Class 2 Permit Modification Request
Removal of Deteriorating/Non-Essential Water Level Monitoring Program Wells

**Waste Isolation Pilot Plant
Carlsbad, New Mexico**

WIPP Permit Number - NM4890139088-TSDF

August 2019

Figure L-14
Groundwater Level Surveillance Wells
(inset represents the groundwater surveillance wells in WIPP Land Withdrawal Area)

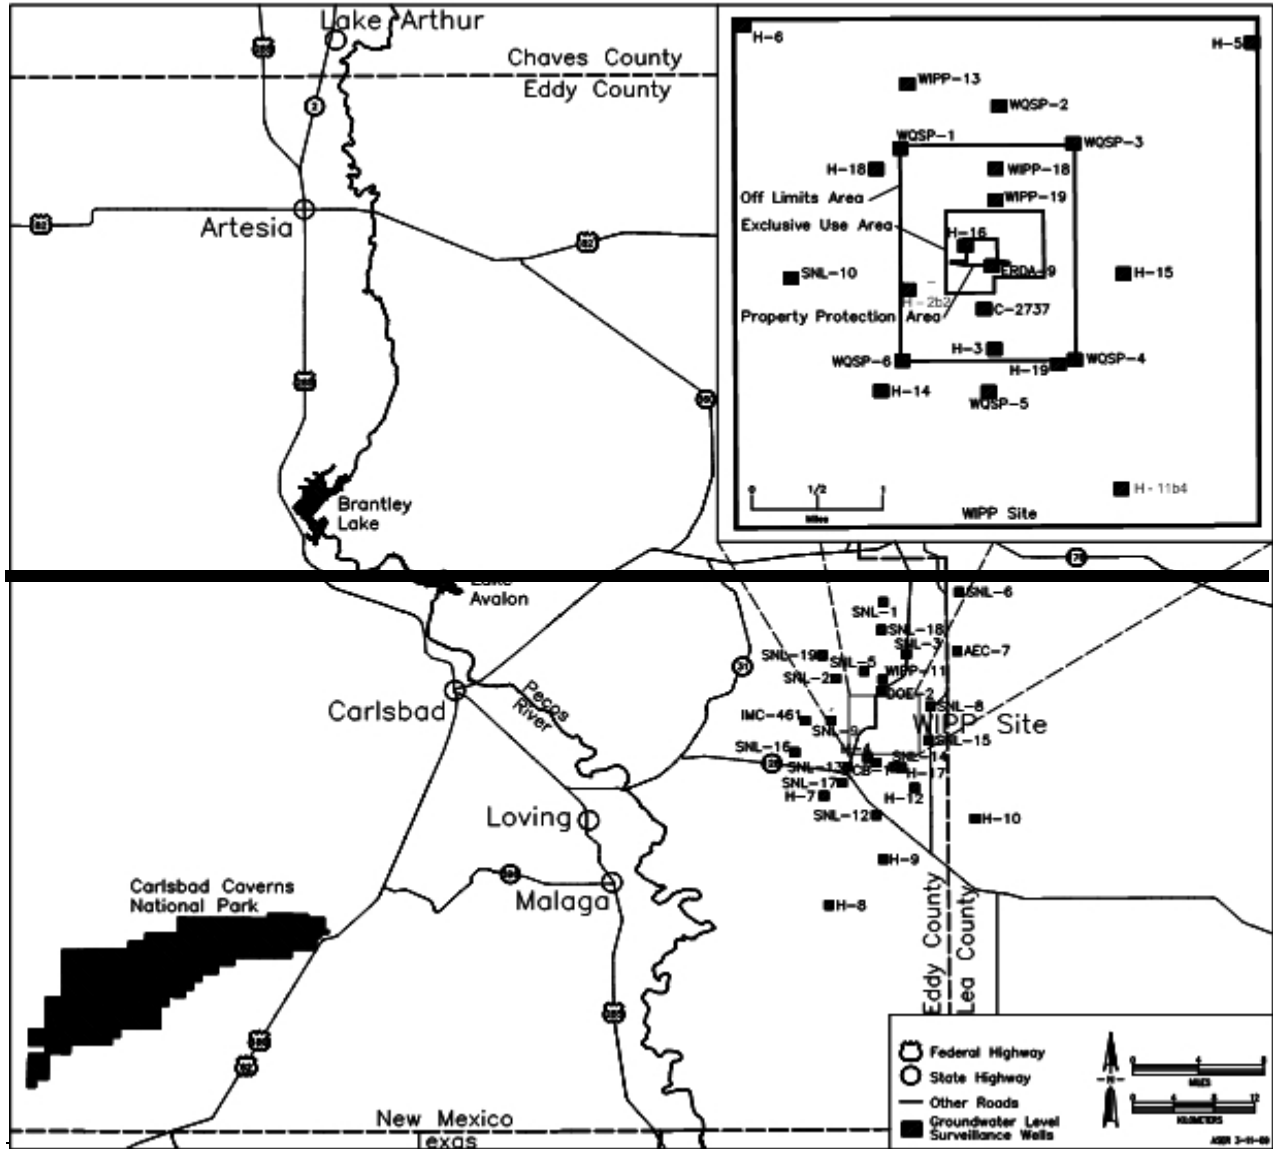
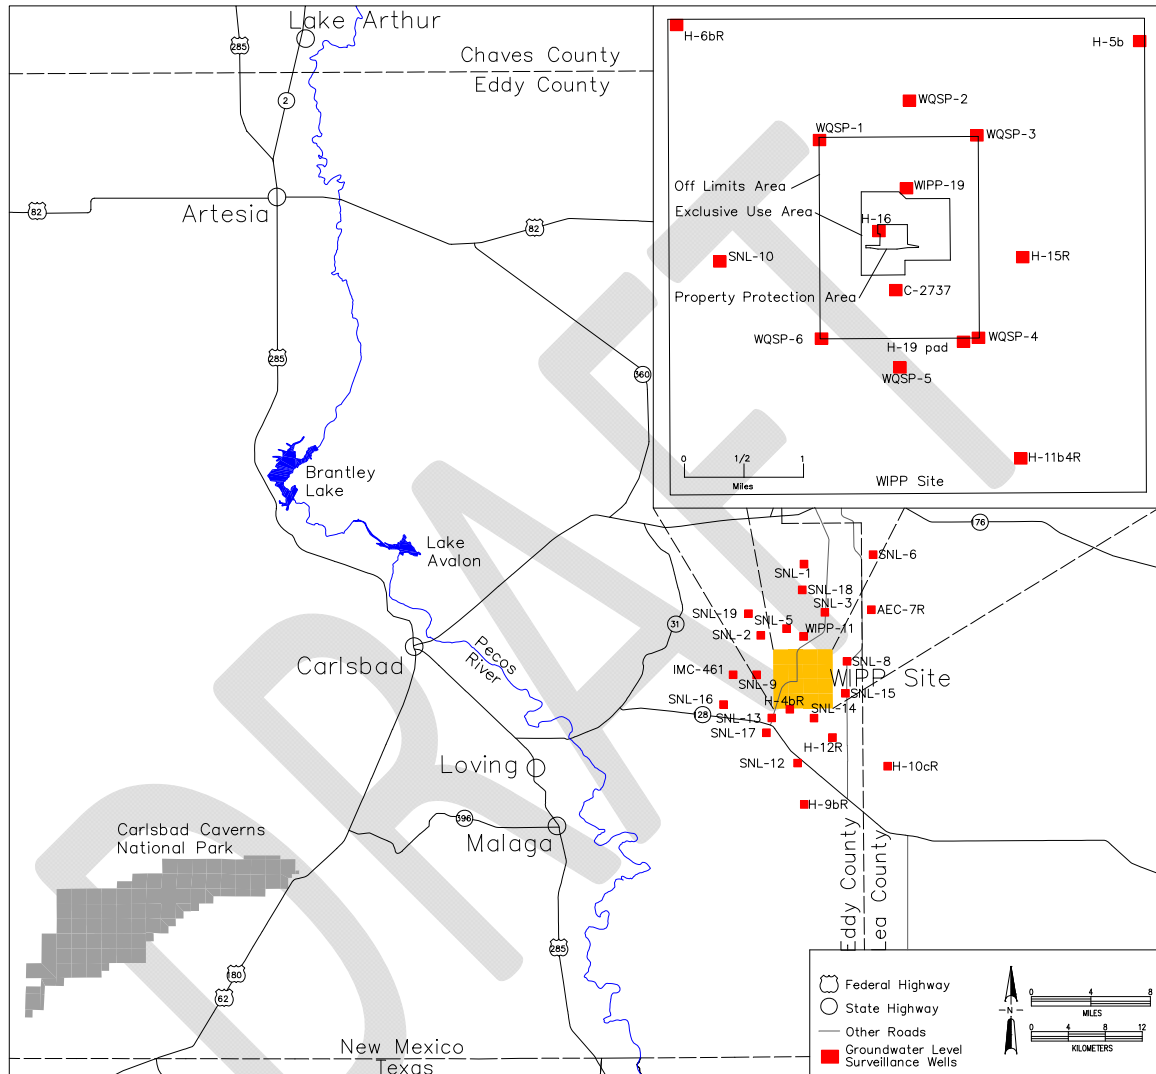
- Permit Attachment L, Figure L-14, *Groundwater Level Surveillance Wells*
 - Remove wells H-18, WIPP-18, H-14, DOE-2, CB-1, and H-8 (as shown in Figure 1).

- Modify the Exclusive Use Area boundary.
 - Delete “ASER 3-11-09” from the bottom right corner of the figure.
 - Change the well identification numbers (as shown in Figure 1) in the figure as follows:

- Replace “AEC-7” with “AEC-7R”
 - Replace “H-4” with “H-4bR”
 - Replace “H-5” with “H-5b”
 - Replace “H-6” with “H-6bR”
 - Replace “H-9” with “H-9bR”
 - Replace “H-10” with “H-10cR”

- Replace “H-11b4” with “H-11b4R”
 - Replace “H-12” with “H-12R”
 - Replace “H-15” with “H-15R”
 - Replace “H-19” with “H-19 pad”

- Permit Attachment L, Figure L-14, *Groundwater Level Surveillance Wells*
 - Wells H-18, WIPP-18, H-14, DOE-2, CB-1, and H-8 need to be removed from this figure because they monitor the Bell Canyon Formation and the Magenta Formation; the WLMP only consists of wells monitoring the Culebra, and as a result, wells H-18, WIPP-18, H-14, DOE-2, CB-1, and H-8 are not listed in Permit Attachment L, Table L-4. These wells had been included in the figure because they were part of the Annual Site Environmental Report in 2009. These wells need to be removed to provide an update to this figure and to assure accuracy and consistency with Table L-4.

- The Exclusive Use Area requires modification to more accurately depict the boundary.

- “ASER 3-11-09” needs to be deleted from the bottom corner of the figure because, with the proposed changes to the figure, it will become an incorrect reference.
